PUBLIC UTILITIES COMMISSION

RE: Mesa 500-kV Substation Project – Minor Project Change No. 14 Request: Additional Splice Work for Telecom Removal

**Attachment A:
MPC No. 14 Figure 1**

MESA 500KV SUBSTATION
MINOR PROJECT CHANGE 14
EXISTING VAULT AND
TSP WORK AREAS

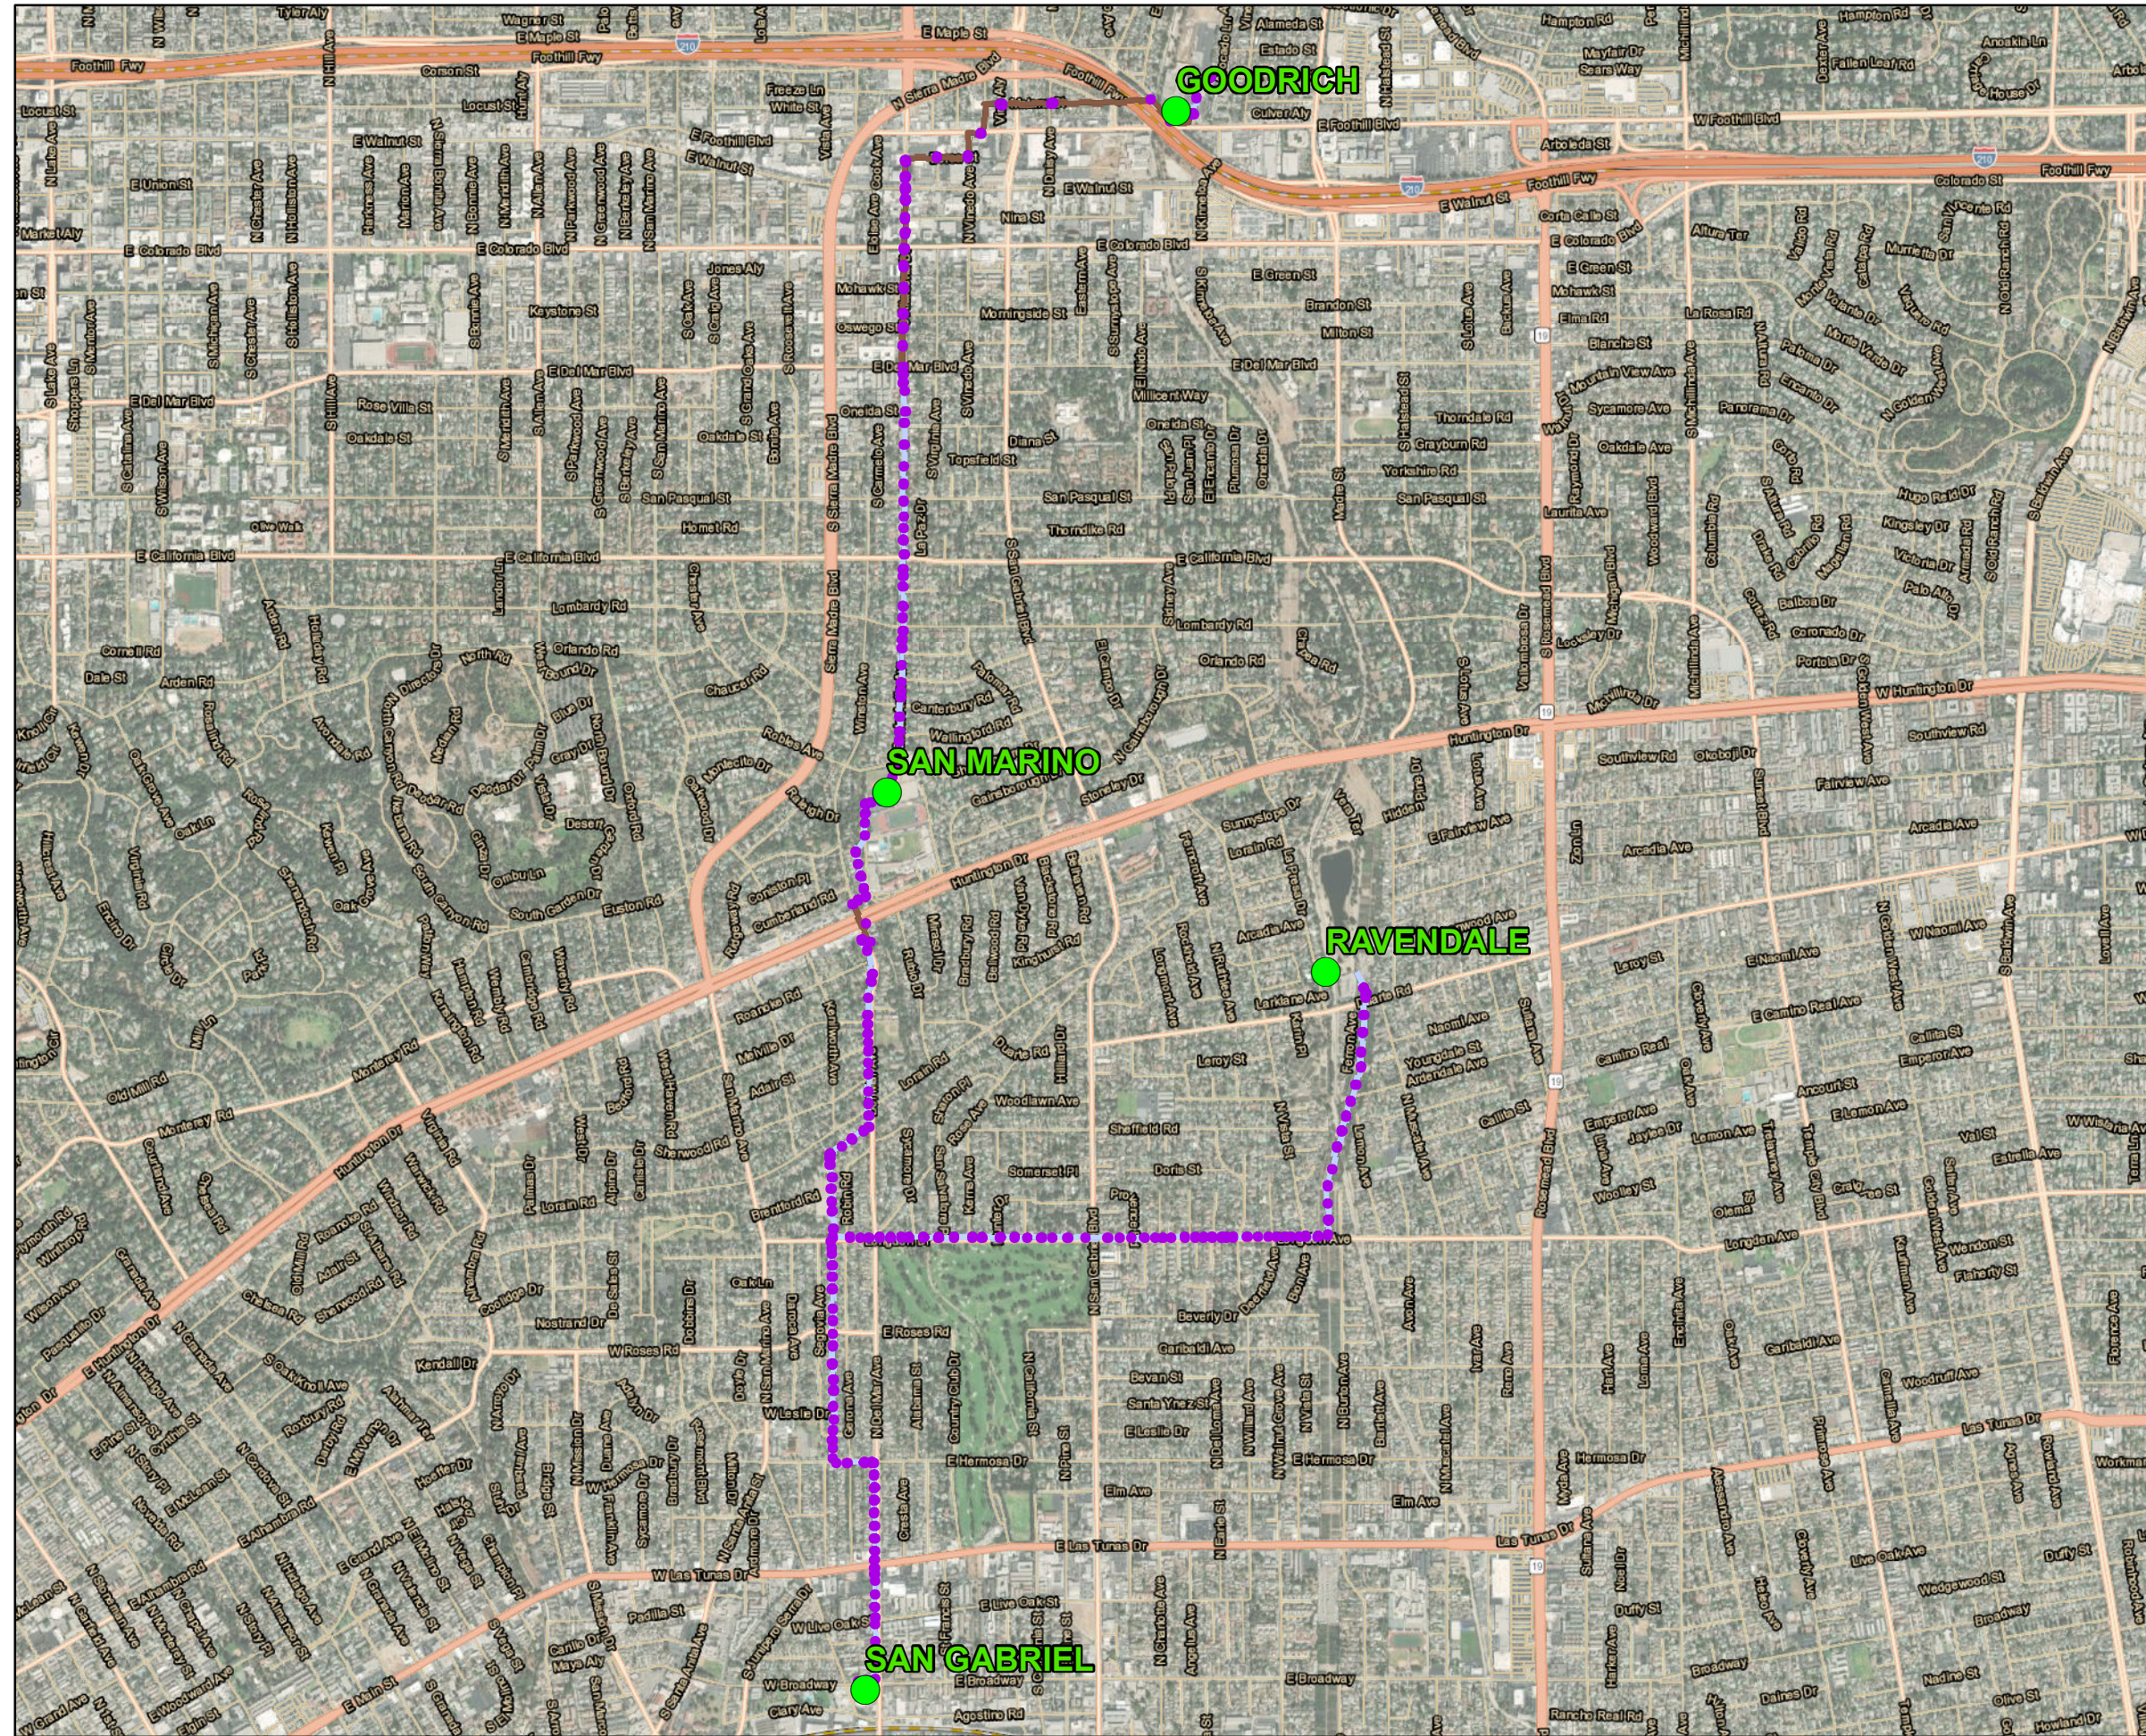
MPC No. 14 removal activities would occur at the following existing locations within the Cities of Pasadena, San Gabriel, and San Marino:

- City of Pasadena
 - Nine (9) wood poles: 1547096E, 1547097E, 4209280E, 1206402E, 1206404E, 1547095E, 207728E, 2077730E, and 2077731E.
 - Twenty (20) manholes and vaults: PB001, V1057, V1076, V1272, V1483, V1528, V1548, V1589, V1634, V1680, V1718, V1813, V1839, V1894, V1907, V2156, V2185, V2266, V2570, and VUKN1.

- City of San Gabriel
 - Seventeen (17) poles: 341265E, 341266E, 341267E, 341268E, 341269E, 341270E, 341271E, 341272E, 341273E, 341274E, 341275E, 341276E, 341277E, 341278E, 341279E, 4161657E, and 4161696E.

- Eighty-two (82) poles: 1229949E, 1541203E, 2013401E, 2013402E, 2013403E, 2013404E, 2013405E, 2013406E, 2013407E, 2013408E, 2013409E, 2013410E, 2013411E, 2013412E, 2013413E, 4171875E, 1206840E, 1206841E, 1206842E, 1206843E, 1206844E, 1206845E, 1206846E, 1206848E, 1206849E, 1237352E, 1237353E, 1237354E, 1237356E, 1237357E, 1237358E, 1237359E, 1237366E, 1237367E, 1237368E, 1237369E, 1237370E, 430261H, 4503110E, 4516799E, 4663202E, 4668004E, 4686756E, 4775372E, 4814035E, 4818697E, 1206850E, 1237360E, 1237361E, 1237362E, 1237363E, 1237364E, 137911E, 137943E, 1429965E, 1541242E, 1541243E, 1541244E, 1547056E, 1547101E, 1547134E, 1724077E, 188821E, 188823E, 1962931E, 2299836E, 341280E, 4022347E, 4219729E, 4283440E, 4305907E, 4391030E, 4435904E, 4437818E, 4469499E, 4537133E, 4537136E, 4575670E, 4694728E, 4694769E, 4723629E, and 85221E.

- City of San Marino
 - Ten (10) poles: 333700E, 341253E, 341254E, 341255E, 4401366E, 473462E, 539098E, 73870E, 73871E, and 73872E.
 - Fifty-six (56) poles: 1431289E, 2005069E, 2354119E, 341256E, 341260E, 341261E, 4774151, 73869E, 966556E, 966558E, 966559E, 966560E, 966561E, 966562E, 966563E, 966564E, 1237371E, 1237372E, 1237373E, 1237374E, 1327714E, 1431957E, 1798913E, 1844666E, 4081663E, 4209164E, 4209271E,

4209272E, 4209273E, 4209275E, 4209281E, 4431460E, 493467E, 493468E, 493469E, 493470E, 493471E, 493472E, 493473E, 493474E, 73588E, 73850E, 73896E, 73897E, 73900E, 742918E, 1279282E, 1432193E, 1723981E, 1723982E, 4209274E, 4761720E, 614327E, 614328E, 73890E, and 937558.

- Five (5) manholes and vaults: M5003449, M5003550, M5003629, M5015346, and V5015347.
